Figure 2. Proposed Madrid Stormwater and Erosion Control Safety Project Area of Potential Effect (APE)

DATE: June 13, 2023
TO: James Hollen, NEPA Coordinator NMAML
FROM: Curt Temple, Public Works Projects Section Manager
SUBJECT: Approval of Environmental Report

From: Kellermueller, Ronald, DGF
Sent: Thursday, July 20, 2023 2:19 PM
To: Murray, Leeland, EMNRD
Cc: DGF-EEP-TG
Subject: RE: No Response Concurrence - Draft EA Madrid Stormwater and Erosion Control Project

Figure 4. Area of Potential Effect (APE) Biological Survey for Proposed Madrid Stormwater and Erosion Safety Project

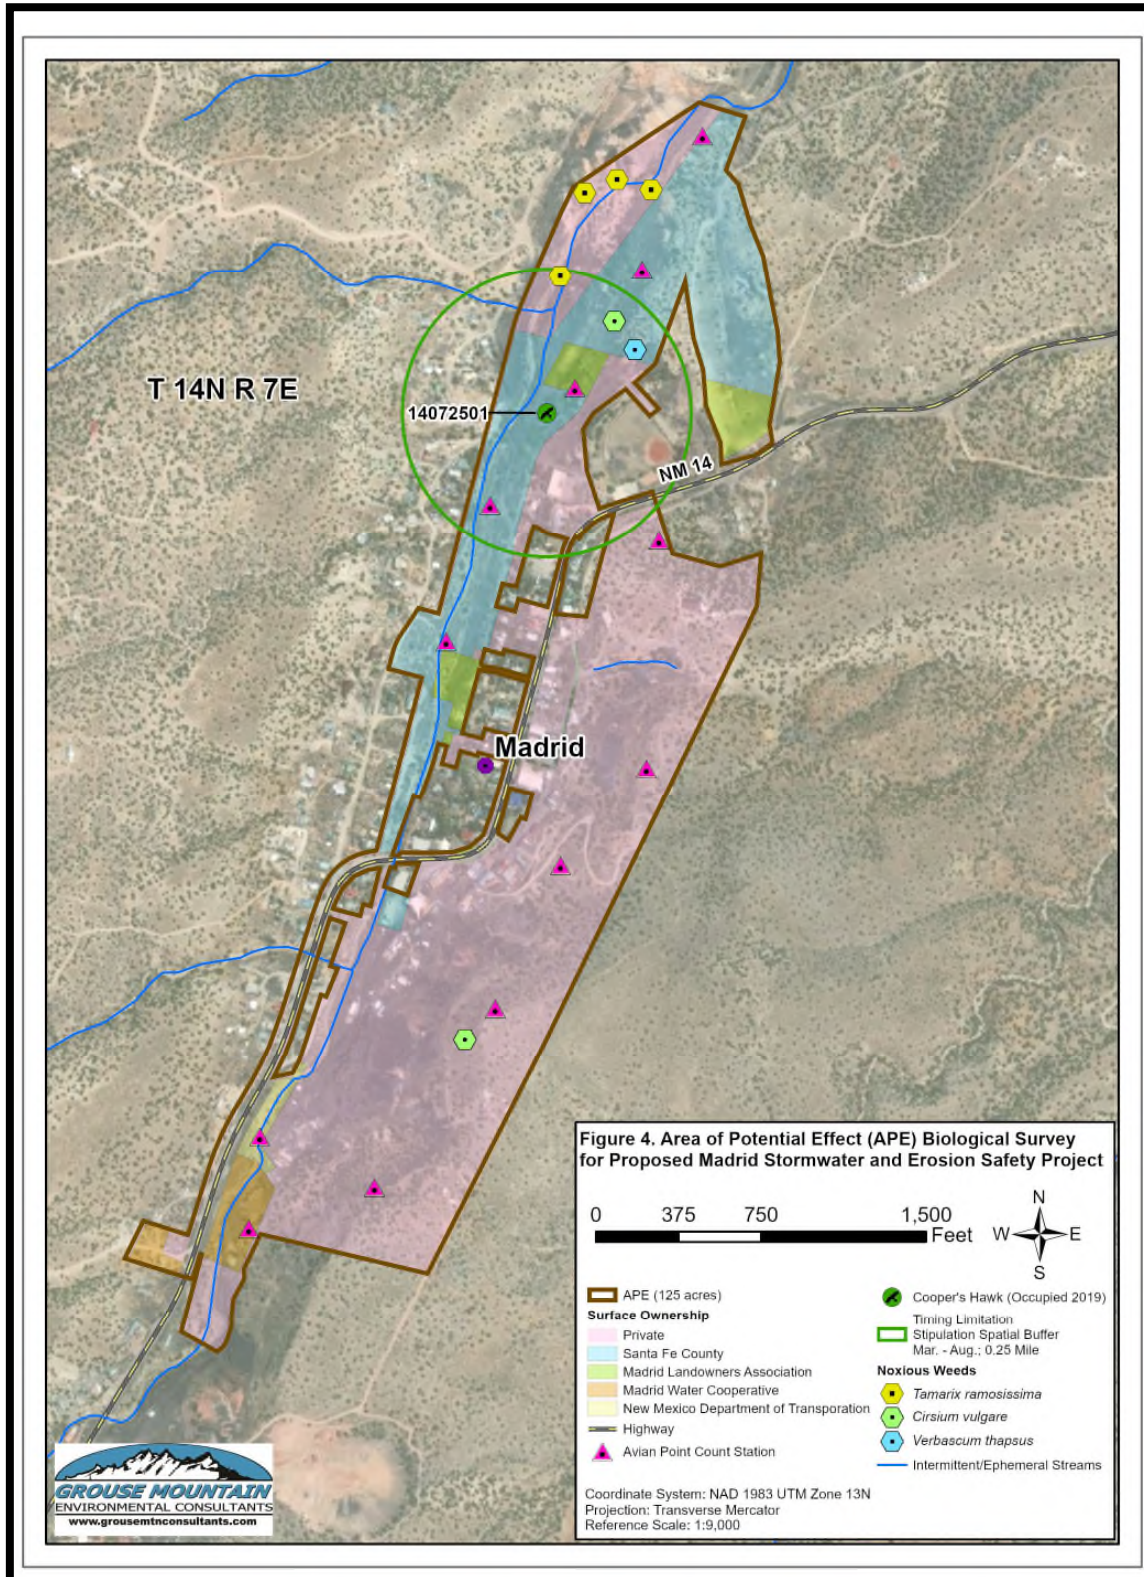
Thanks for arranging a site inspection today (20 July 2023) regarding the above referenced Madrid Stormwater and Erosion Control Project. Two fully feathered Cooper's Hawk nestlings were observed at the nest near the proposed project area, and an adult female was also observed near the nest site. The young fledglings are most likely capable of limited flight and have begun periodically branching away from the nest and should be fully fledged by the end of the month.
